Duluth Heights Community Club

Accessibility Review

Transition Plan - (location/priority)

Photo 1: An accessible parking space has been designated near the building. There is currently slope within the parking space causing water and ice to build up.

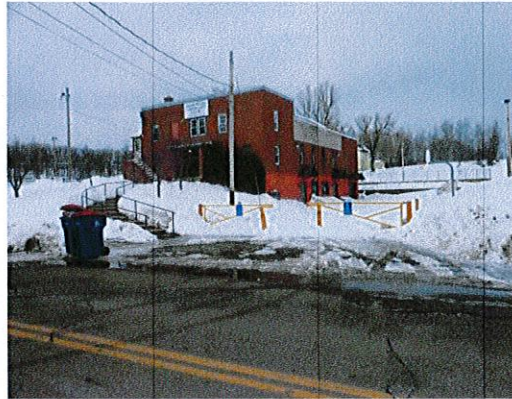
Parking									
05N 16398	Alter the slope of the accessible parking stall and / or access aisle to be no greater than 1:48 (2%) in any direction. ICC / ANSI 502.5 <i>There is currently a slope exceeding 2% near the head end of the accessible parking spaces, causing flooding and ice build-up. Photo 1.</i>	1	\$500	\$500	4				
Women's Toilet Room- Lower Level									
22-20A 16388	Widen door opening to provide a minimum 32" clear opening. ICC / ANSI 404.2.2 <i>Currently provides 27" clear opening. (There is no door.)</i>	1	\$1,500	\$1,500	4

Photo 2: There is not currently an interior accessible route between levels. An on-grade entry is provided to the upper and lower levels. (There is not currently a route to the 3rd floor former apartment.)

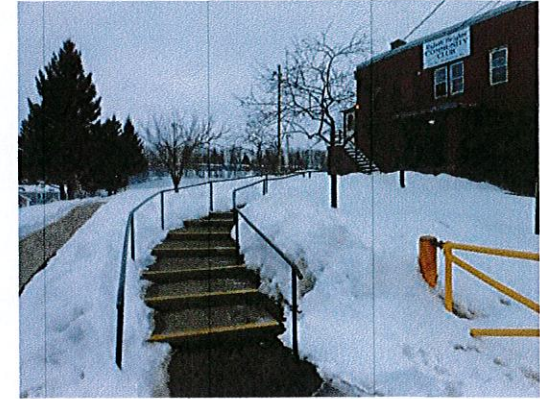
Location JQP # / Item #	Solution / Comments	Qty	Unit Cost	Total Cost	Priority	Estimated Compl. Date	Person Responsible	Actual Compl. Date	Actual Cost
Concessions- Lower Level									
27B 16386	Modify / replace sink and / or counter so rim is no higher than 34". ICC / ANSI 606.3 <i>Currently at 36".</i>	1	\$1,000	\$1,000	4				
Drinking Fountain									
41A1 16390	Provide a minimum of one drinking fountain that has a 36" spout height accessible for persons using wheelchairs (low) and one standard height (high) drinking fountain with a spout height 38" minimum and 43" maximum for persons who have difficulty bending or stooping. ANSI 602.4 <i>There is currently 1 drinking fountain at 36".</i>	1	\$1,500	\$1,500	4				
Duluth Heights									
14D1 16400	Provide a fully compliant elevator to provide access between levels. MN 1341 1104.4 and 402.2 <i>There is not currently an interior accessible route between the levels. (On-grade entries are provided to the upper and lower levels.) There is minimal program interaction between the upper and lower levels; no action recommended at this time. Photo 2.</i>	1	\$0	\$0	4

Photo 4: Reconfigure the accessible parking. If a vehicle were in the space on the right it would block access to the route to the upper level.

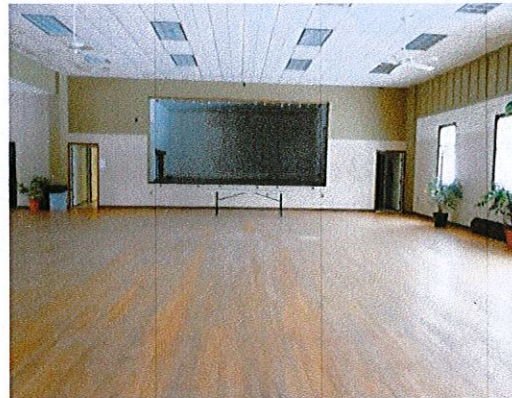
Location JQP # / Item #	Solution / Comments	Qty	Unit Cost	Total Cost	Priority	Estimated Compl. Date	Person Responsible	Actual Compl. Date	Actual Cost
Parking									
16399	<i>Relocate the accessible parking spaces, they currently block the route to the building. Photo 4.</i>	1	\$0	\$0	2				
				Priority # 2 Total	\$0
